IN THE DRAWINGS

Please replace drawing sheets 1-5 with the attached replacement drawing sheets 1-5. The drawings have been modified to correct the objections listed on the Notice of Draftsperson's Patent Drawing Review Form included in the present Office Action. The line weights have been reviewed and adjusted to ensure they are consistent thickness and the reference number heights have been reviewed for height accuracy.

FIG. 1

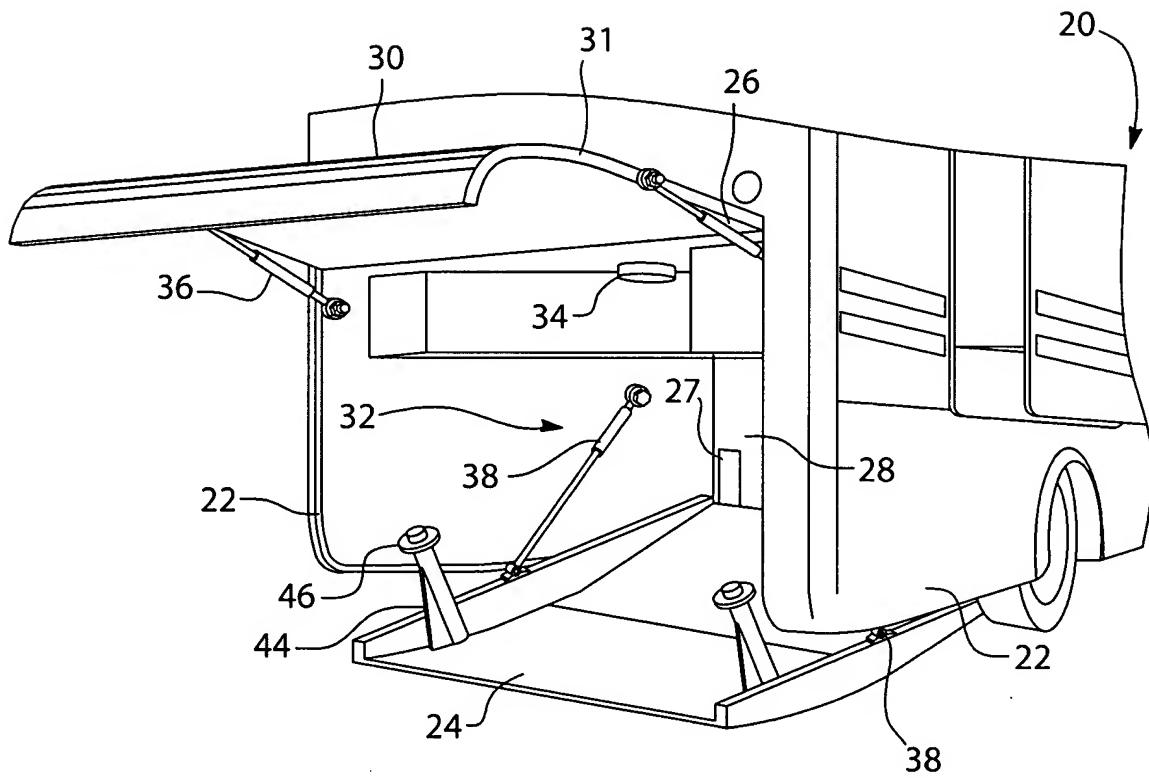
Figure 1 has been amended to include an access door 27, hydraulic lift cylinders 38, and hatch edge 31. Access door 27 was included in the original specification on page 7, line 14 and in claim 18. Therefore, the addition to the drawings of access door 27 does not add new matter to the application.

Hydraulic lift cylinders 38 are shown in the original drawings as well as the specification and claims and therefore do not present new matter. The hatch edge 31 was disclosed in the specification on page 7, line 20 and has been added to Figure 1 with a reference number for further clarity and also does not add new matter.

FIG. 2

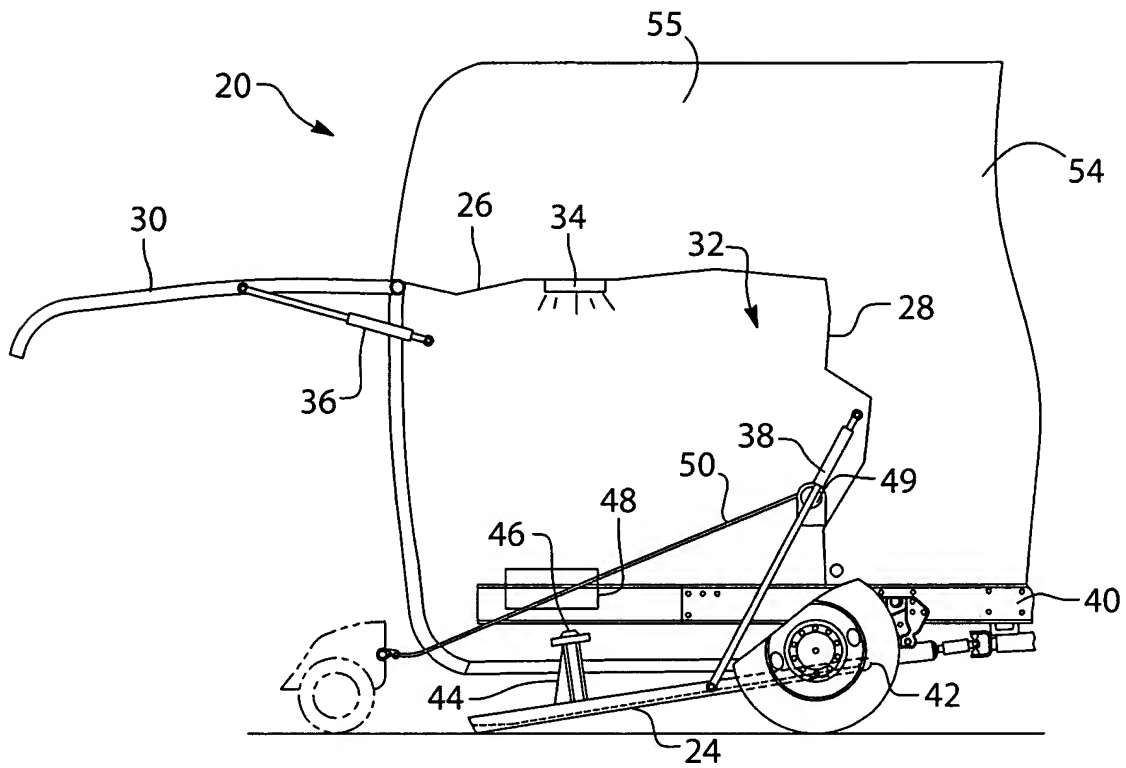
Figures 2 and 3 have been amended to include reference numbers 55 and 49 and to correctly identify reference number 50. Reference number 55 was

added to the drawings to identify the additional storage space above the storage compartment as disclosed in original claims 15 and 18. Reference number 49 was added to indicate the winch device and reference number 50 has been amended to correctly identify the cable. Both the winch device and cable were disclosed in the original specification on page 8 lines 21-23 and therefore are not new matter.

Previous Figures 2, 3 and 5 contained a straight line indicating a view into vehicle 20. This straight line has been replaced with a wavy line to better indicate a cut away view into the vehicle 20 and has been made for clarity purposes.

FIG. 4

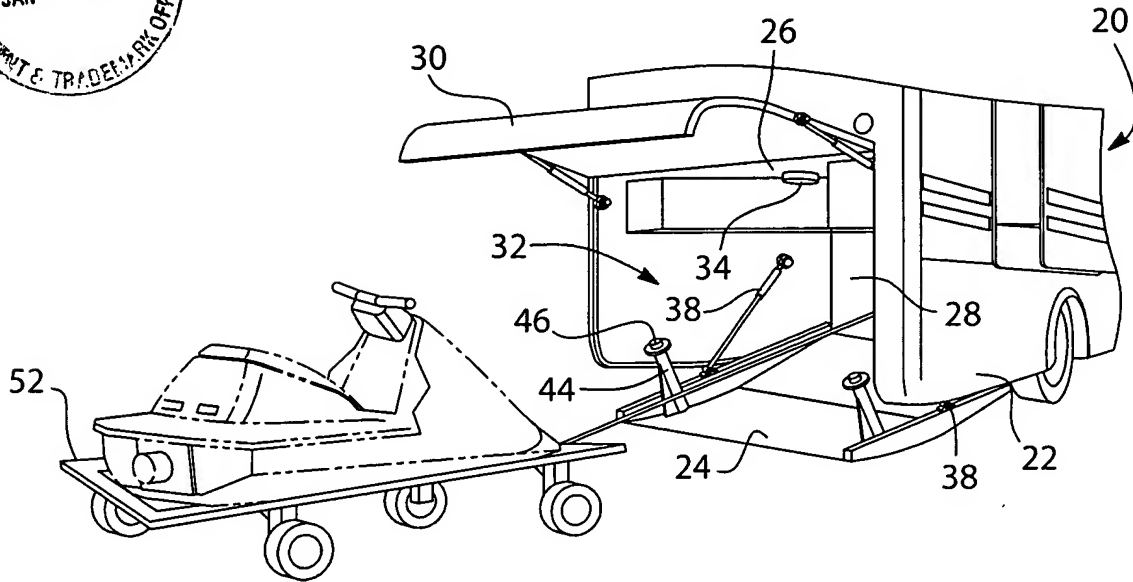
Figure 4 has been amended to add hydraulic lift cylinder 38. Hydraulic lift cylinder 38 was disclosed in the original specification and drawings and has been added to Figure 4 for clarification.

FIG. 6

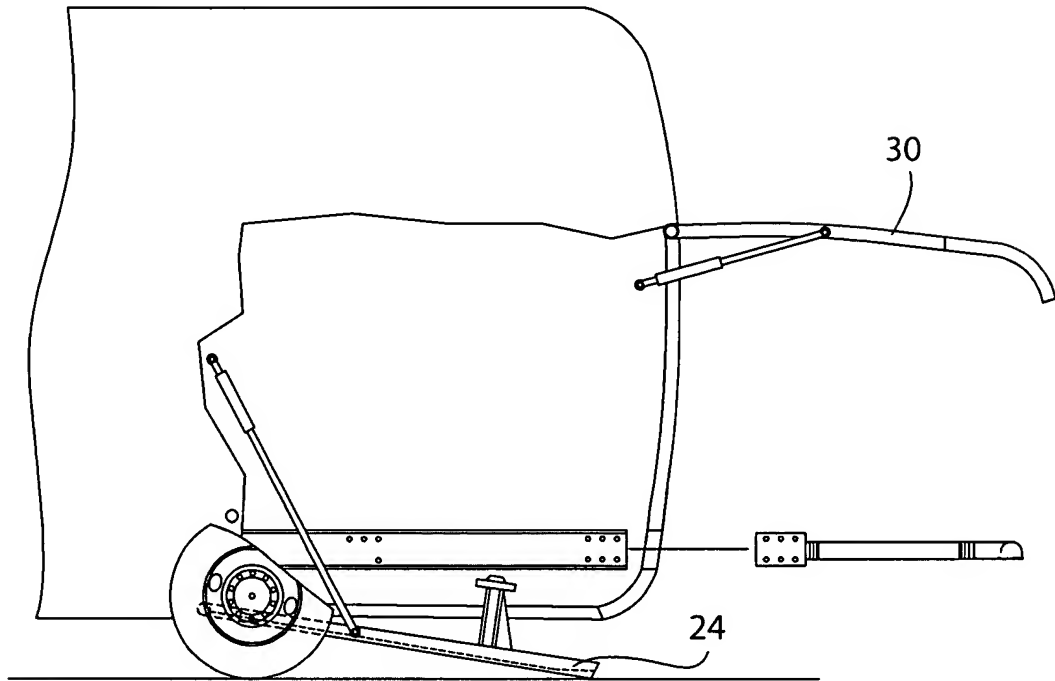
New drawing sheet 4 contains new Figures 6 and 7. Figure 6 has been added to show the hatch located in the front of the vehicle as disclosed in the original specification on page 7, lines 2-5 and original claim 17. Figure 7 has been added to show a second hatch located in an adjacent body panel as disclosed in the original specification on page 7, lines 5-7 and original claim 11. Figures 6 and 7 do not present new matter.

FIG. 8

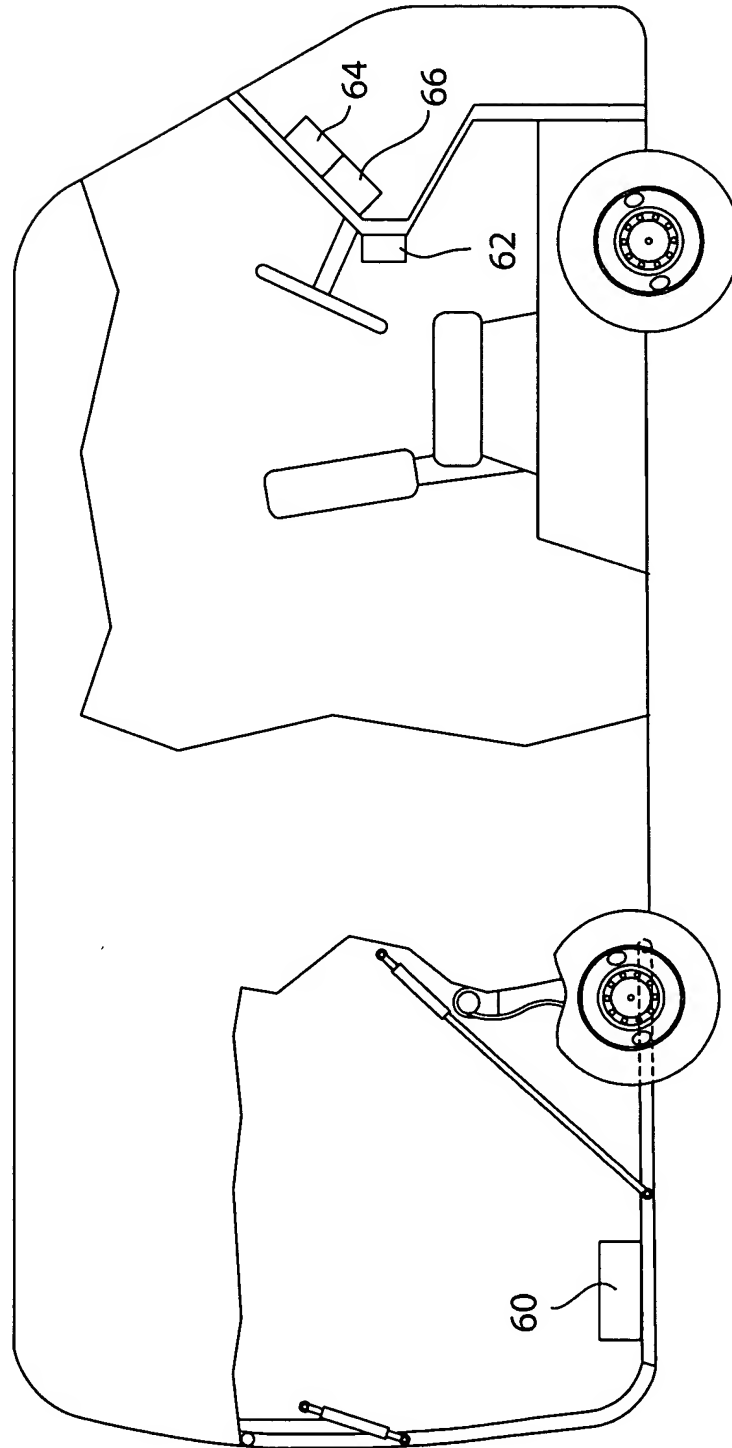
New drawing sheet 5 containing Figure 8 has been added to show means to prevent the vehicle from moving as disclosed in the original specification on

page 10 lines 1-14 and in original claims 12-14, and therefore does not add new matter. Figure 6 includes an indicator lamp 62, a PRNDL Gear Selector sensor 64, a drop deck position sensor 60 and a kill switch 66.
